# DeKalb County Historic Preservation Commission

## Staff Report

M. 1228 Oxford Road, John Stubbs and Caroline Quillian Stubbs. Replace driveway, remove nonhistoric stairs, and replace porch tiling. **1246968**

| Title: | Site Plan based on previous survey, county plat, and ground measurement. | Scale:   | 1/4"=1'-0" | Date:    | 03/24/2024 | Rev:   | A |        |  |

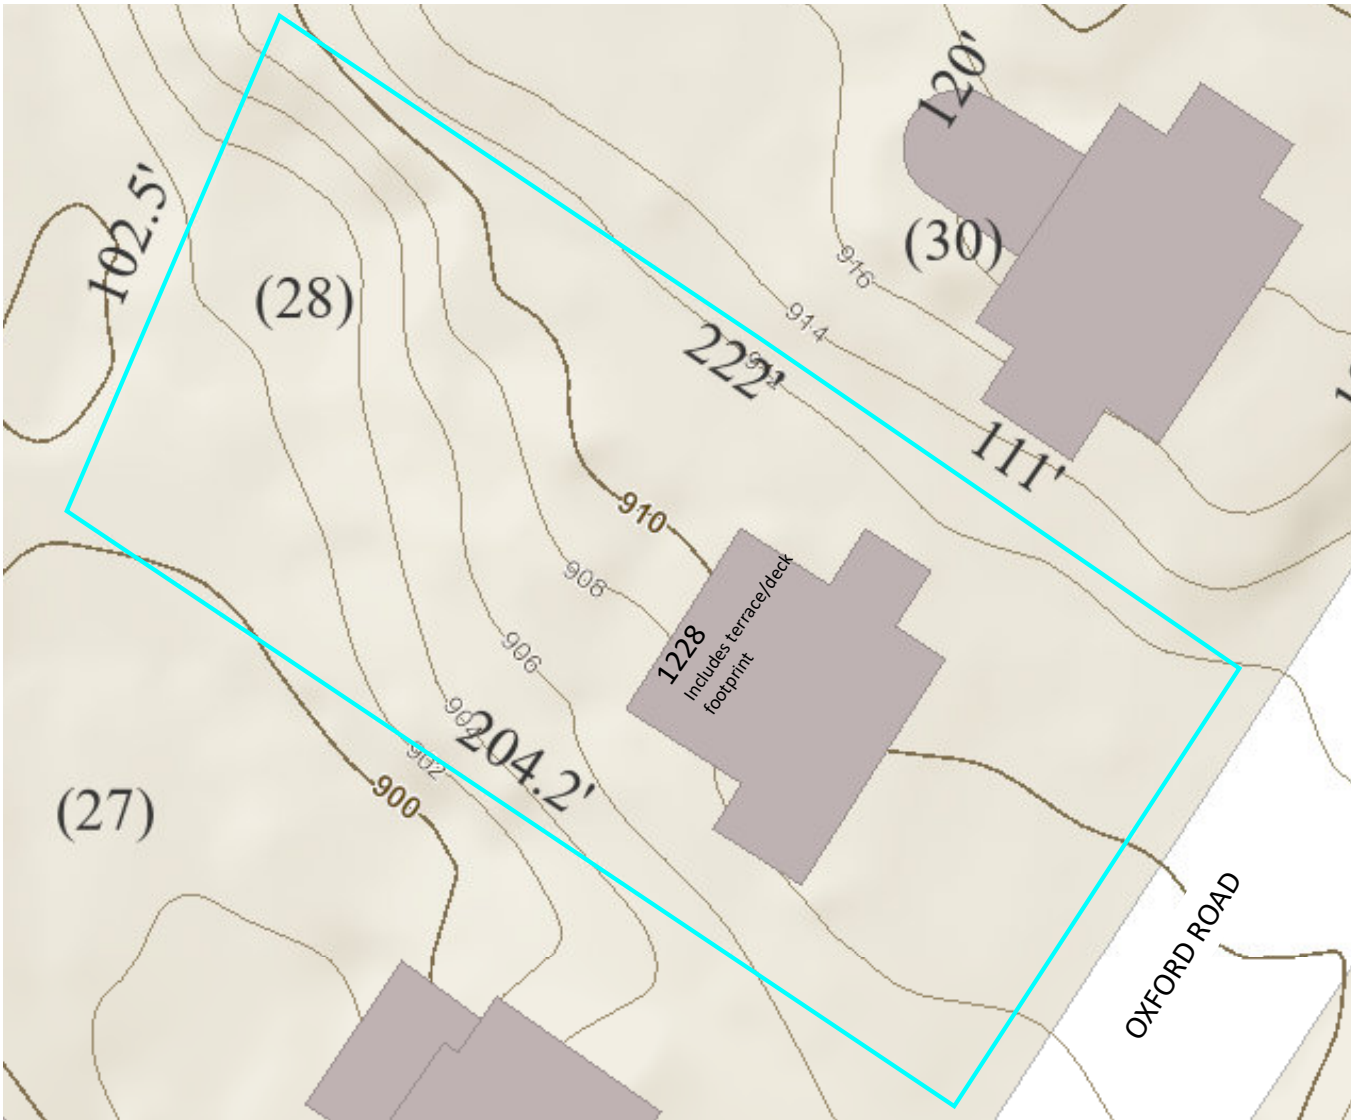
**Will the driveway be widened or narrowed?**

The driveway will not be widened or narrowed, we intend to keep the same footprint for the driveway as it exists now.

Existing conditions: Non-historic concrete stairs to be removed

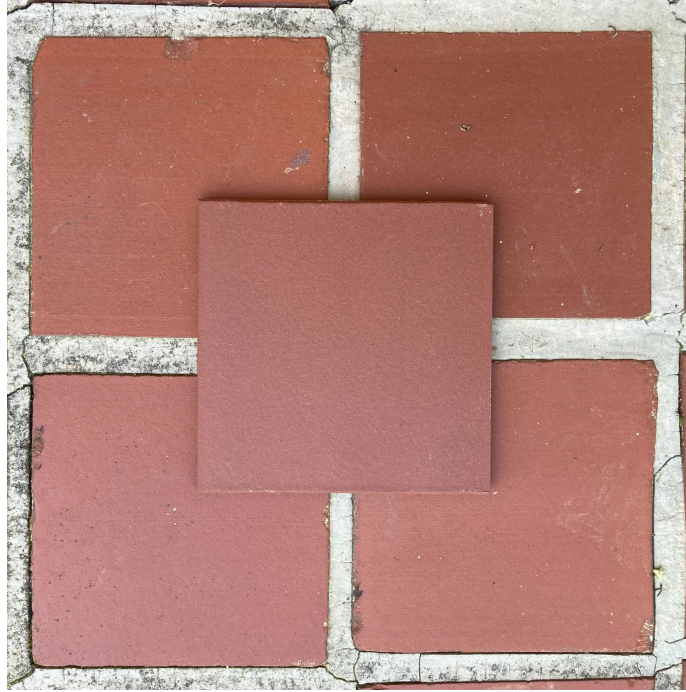
**Approve with Modification.** The tile for the front porch should be replaced without removing or causing harm to the exterior masonry of the house in accordance with Guideline 6.1.1.

**How will the brick where the concrete stairs are removed be repaired?**

It appears that the concrete stairs were a poorly done add-on. The stairs have visibly separated from the brick to a small extent, so the yellow bricks behind the stairs may be in reasonably good shape and the stairs have a good chance of simply falling away from the brick during demolition. We will not know the answer until the stairs are removed. As for repair, we would repair/rebuild as needed with reserve salvaged brick on hand. Treatment with a light acid masonry wash could also be used to remove any staining, but that would depend on the conditions encountered.
